TO: Rapid City Planning Commission

FROM: Tamara M. Pier

RE: File# 02PL085  
Canyon Lake Heights Subdivision  
Preliminary Plat

DATE: August 29, 2002

**PRELIMINARY PLAT**

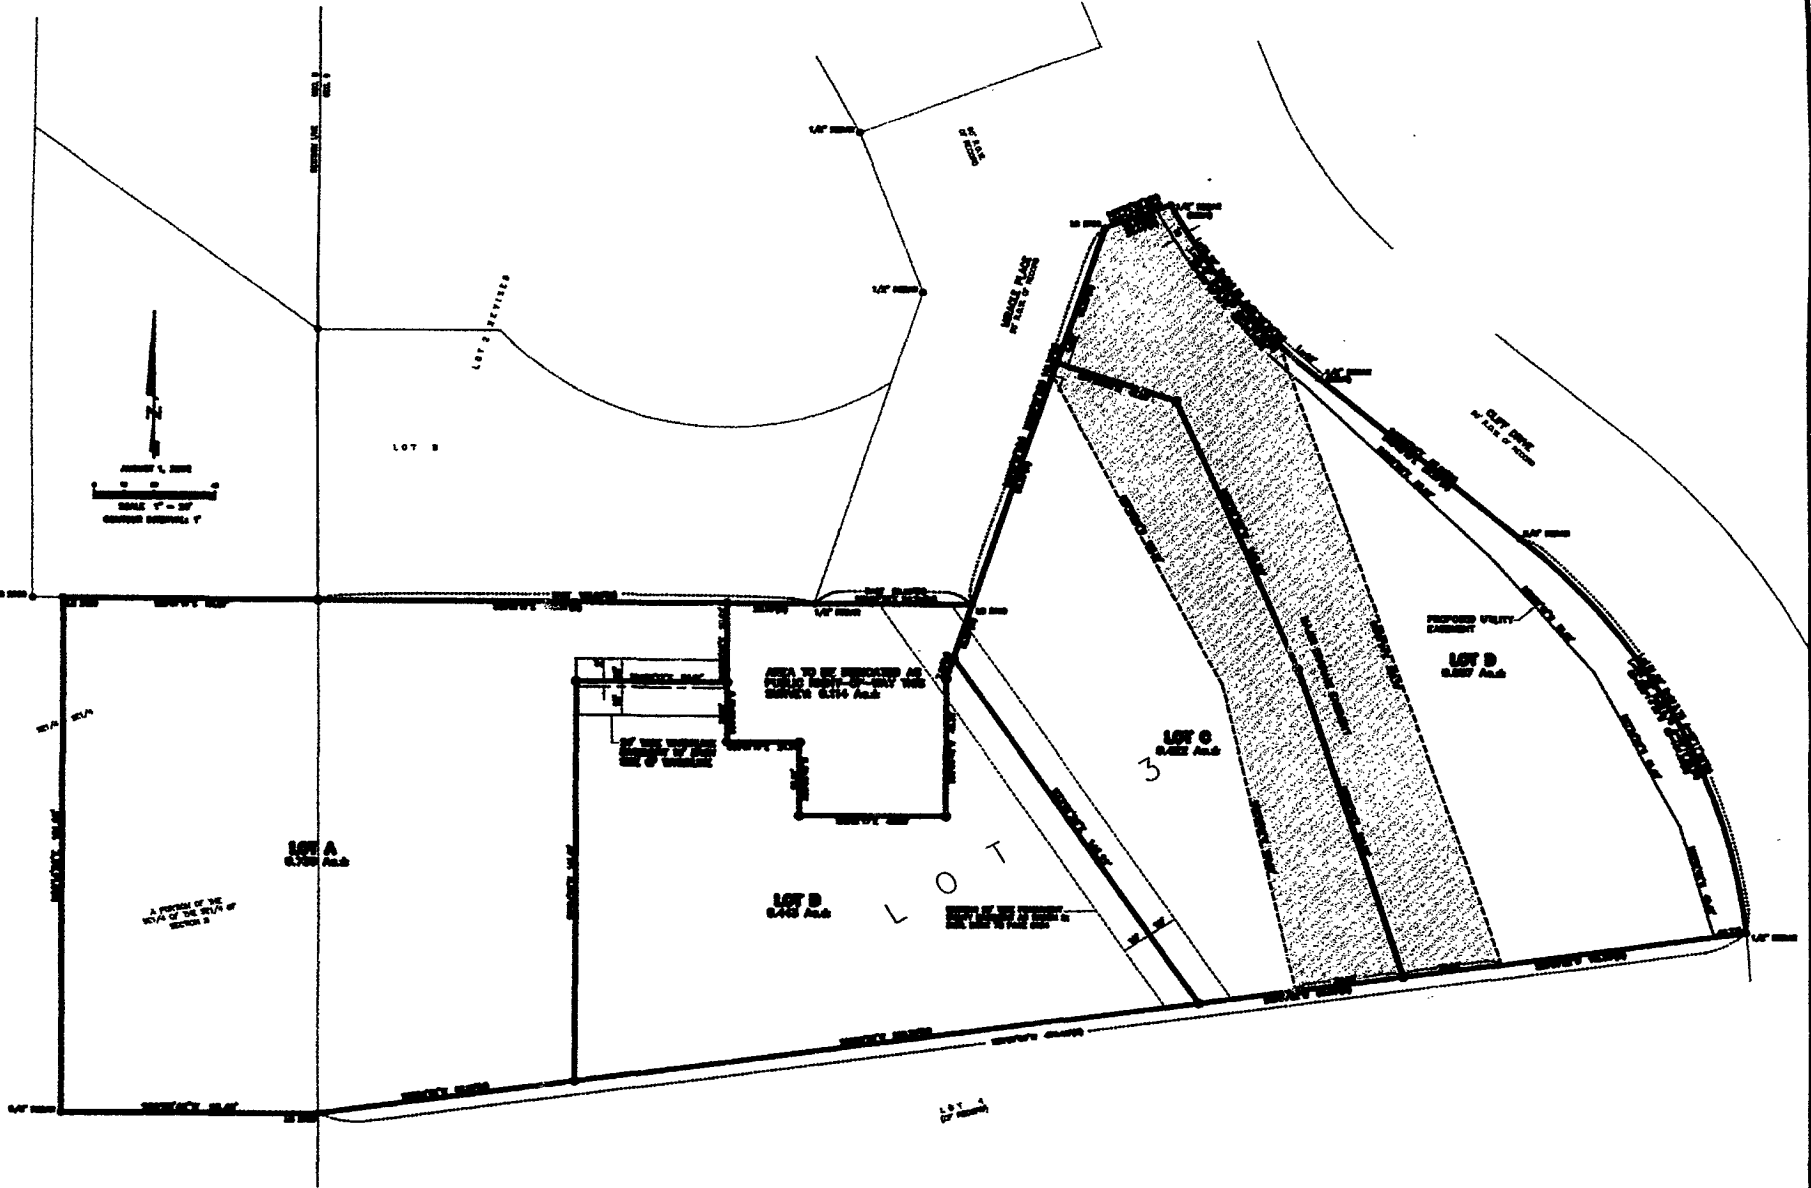
3) Lots. The neighbors are also of the opinion that the proposed Lots C & D are not appropriate for the location of the subdivision or for the type of development and use contemplated. See, RC Municipal Code, Section 16.12.190. In reviewing the applicant's preliminary plat, it is to be noted that a large portion of both Lots C & D are major drainage easements. (See attached copy of preliminary plat.) Although the proposed lots certainly meet the square footage requirements for the LDR zoning district, they are inappropriate because of the drainage easements and street access problems they pose. The adjoining neighbors realize that the owner of this lot has a right to develop the existing lot, but believe that a lower intensity of use through fewer lots would be more appropriate to the area.

1. As per Rapid City Ordinance 16.12.190 regarding design standards for subdivisions, the lot shape, size, width, depth, shape, etc. shall be appropriate for the location of the subdivision. The existing Lot 3 is a long and narrow lot. As per the new proposed lot layout plan, four structures would be in a somewhat row from front to back. Also, with the proposed easements, turnarounds, and structures, an estimated 60 to 70% of the existing pine trees would have to be cleared. We believe that the proposed lot split into four parcels is not appropriate for the Canyon Lake Heights Subdivision.

4. A Special Exception was requested and granted to allow Cliff Drive to serve as access to proposed Lot D in lieu of Miracle Place. The proposed location is across from an existing driveway located directly east of Cliff Drive. This driveway directly east of Cliff Drive from the new proposed driveway is very steep, approximately 13.8% slope. In ice or snow conditions, we have seen vehicles slide across Cliff Drive. If there is another residential driveway directly across from this drive, we feel there would be a safety concern. Now the vehicles drive into the grassy area across the street before stopping. If a new driveway is allowed across the street and possibly the location of the proposed new

A copy of the plan sheets showing lot size and configuration has been forwarded to you under separate cover. Note that we propose to plat a major drainage easement between Lot C and Lot D. While the current configuration of Lot D provides frontage to Miracle Place, a driveway would be required across the major drainage easement. In lieu of taking access from Miracle Place, we propose to provide access to Lot D from Cliff Drive. The driveway entrance can be aligned opposite of the existing driveway, as noted on the plan sheets. Access from Cliff Drive will eliminate the need for paving or driveway development within the major drainage easement.
